Expert Opinion Report - Rectification

10-12 View Point Road, McCrae

PSM5226-005R 11 June 2024

Inset 2: Excerpt from CivilTest report 1222044-1 Issue 2 (5 December 2022) (Document 2, pdf page 4)

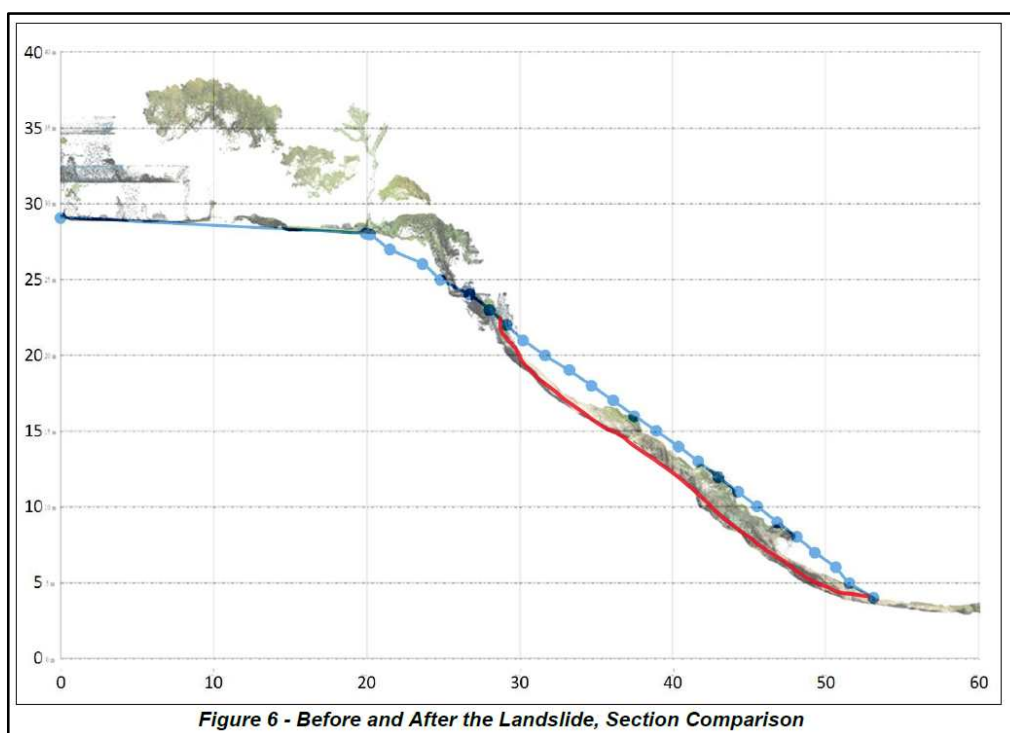
- (d) The steep head scarp depicted in CivilTest drone survey (Inset 2) and models (ref) is an artefact of creating a thick cross section line from the drone model. i.e. the head scarp feature depicted by CivilTest at the crest of the escarpment does not exist on Site (refer to Paragraph [9(a)]).

Inset 4: CivilTest section with proposed RW remediation (Document 12, pdf page 29). I have added my commentary in blue.

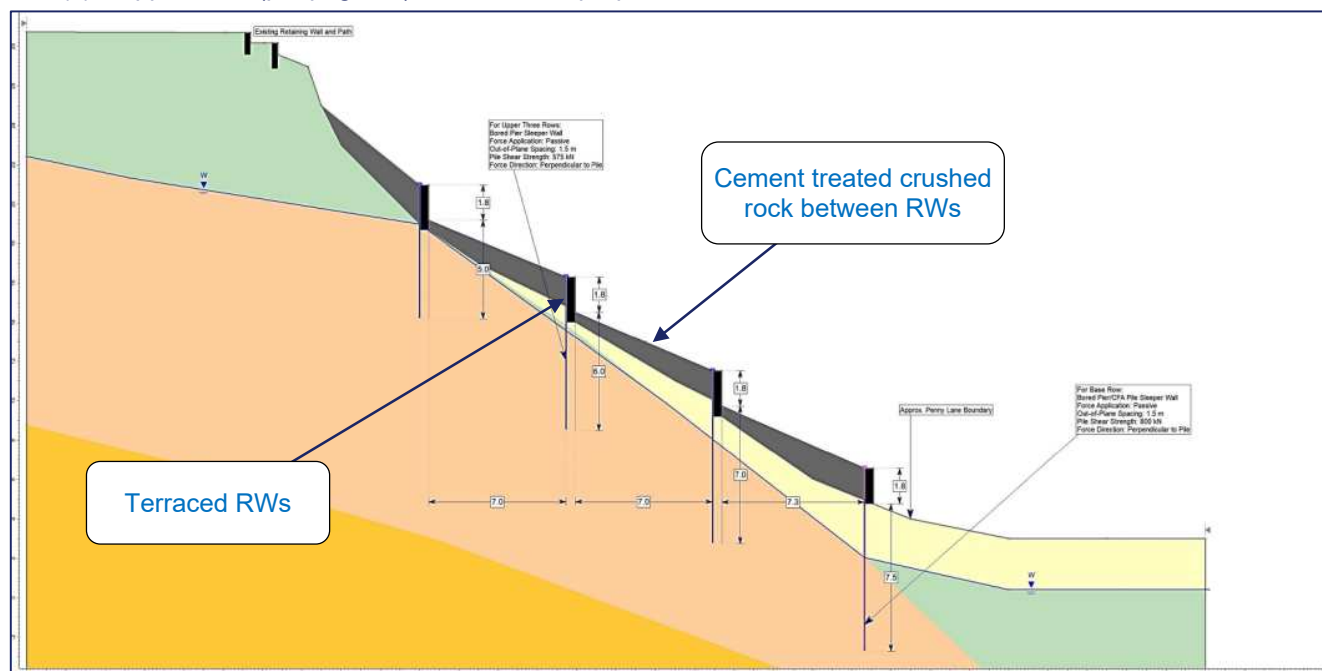
- (a) Section 6.4 (pdf page 11) describes the proposed “Slope Stabilisation System” to remediate the Landslide and includes:
 - i. Four rows of retaining walls (RWs).

- ii. Cement treated crushed rock (CTCR) placed between retaining walls with a maximum 22 degree slope angle.
 - iii. *“Loose colluvium/landslip material should be removed from the slope”.*

- (b) Appendix E (pdf page 29) illustrates the proposed remedial works in section view, Inset 4.
